Town of Medway **DESIGN REVIEW COMMITTEE**

DRC Meeting Minutes: July 31, 2017

Medway Public Library – 26 High Street

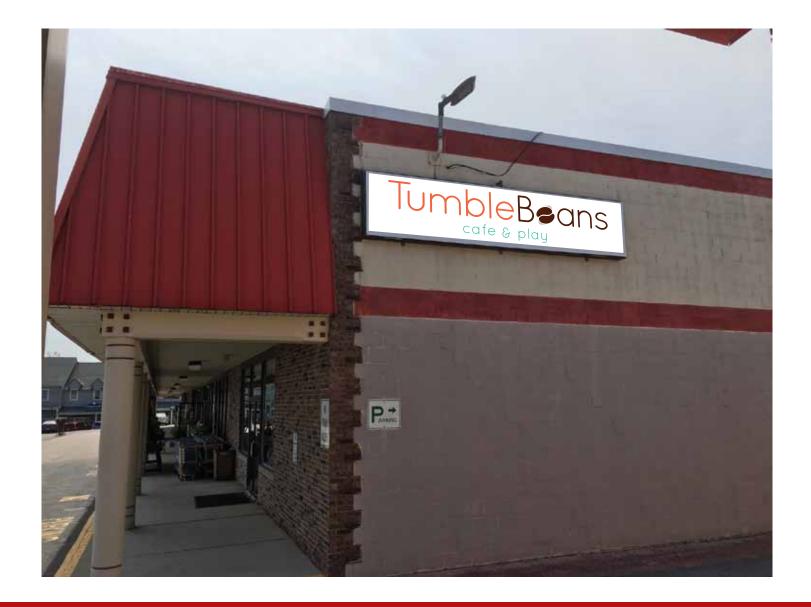
1. **Wall Sign** – Individual Letters – 35" by 164" above entry on east building facade

Proposed	Allowed by Bylaw
Sign Surface Area	35" x 164" = 39.86 sq. ft.	OK
Sign Height	Not applicable for wall sign	Not applicable
Illumination	None	Yes

- 1. New business. Location is at the back of the east side of the building where Condon's Hardware and Ocean State Job Lot located. The space was formerly occupied by an auto parts store.
- 2. Width of business frontage = 133'
- 3. Box cabinet type of sign is an outdated type of signage, not really in keeping with the hip nature of the business and contemporary style business graphics/logo.
- 4. NOTE Bylaw allows only one wall sign per façade. So, only one of the two proposed wall signs can be permitted at this time.

- a. The business could seek a variance from the ZBA to allow for the second wall sign.
- b. The business could have one "Projecting Sign" (side hanging off of a bracket) of 12 sq. ft. in size, by right, instead of one of the wall signs. It could be positioned perpendicular to the building façade up close to the front of the building near the hair salon. This type of sign may actually be more visible than the box cabinet sign to people parking in front of Condon's and Ocean State. Key issue is the height of the sign as the driveway is adjacent.

Tumble Beans — 17.8" — 7"

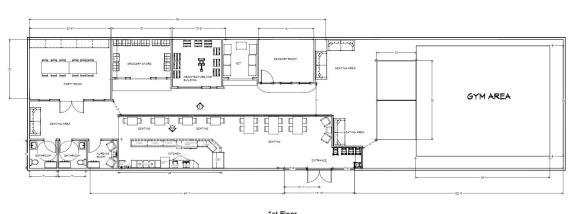
2. **Wall Sign** – One Box Cabinet sign – 36" x 168" replacement panel for existing box. Internally illuminated.

Proposed	Allowed by Bylaw
Sign Surface Area	36" x 168" = 42 sq. ft.	OK
Sign Height	Not applicable for wall sign	Not applicable
Illumination	Internal	Yes

Revised site plan dated July 19, 2017 – See sheet C-4 for revised landscaping plan

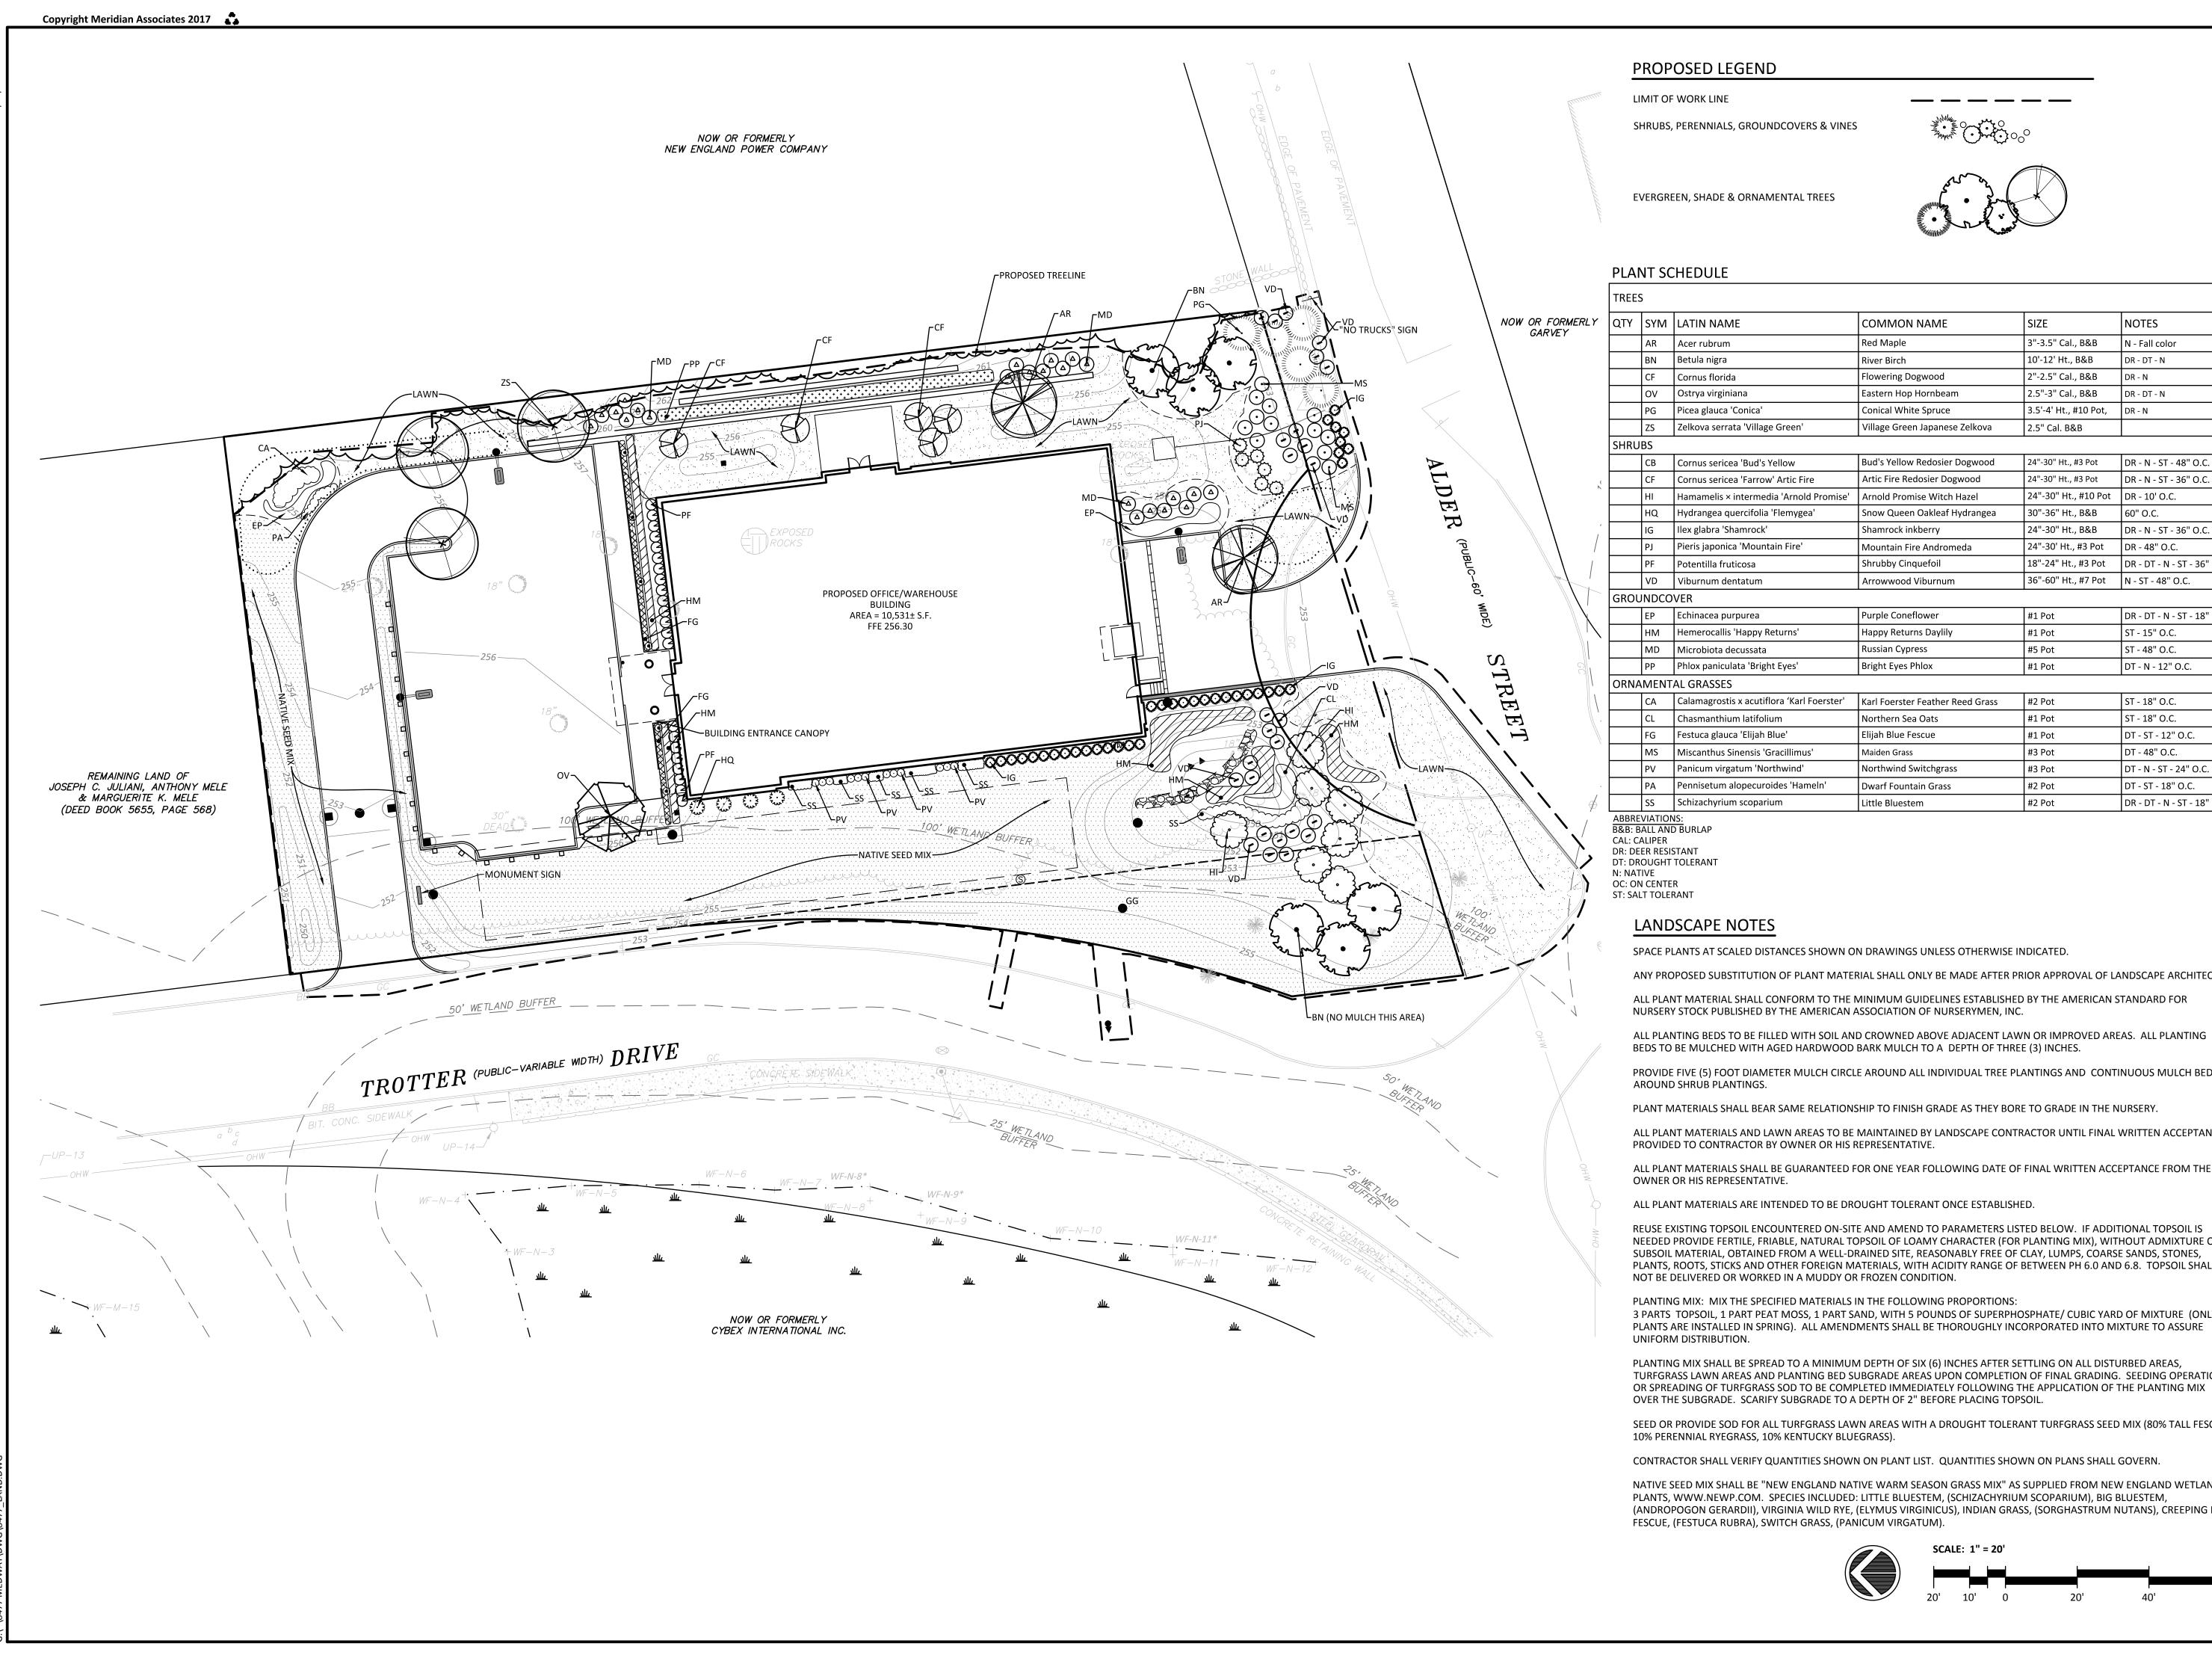
get sign permits, DRC should do a site visit. For walls within the site, existing stones will be used as proposed by the Committee. Ms. Affleck-Childs said the height of the dumpster enclosure should be tall enough to cover the dumpster. She recommended checking the height of the enclosure and the dumpster with the vendor before it is installed. Applicant is meeting with the Planning Board next week. Mr. Buckley will draft the DRC's recommendations before that meeting.

• The DRC recommends that the landscape buffers on the Alder Street side of the site provide more robust and natural screening by using the combined elements of a landscape berm, low fieldstone style wall and vegetation. This site will be the first building at the edge of the adjacent residential zone and efforts should be made to transition smoothly from the residential to the industrial zone. The introduction of landscape and fieldstone wall at this edge will produce a better, more attractive transition.
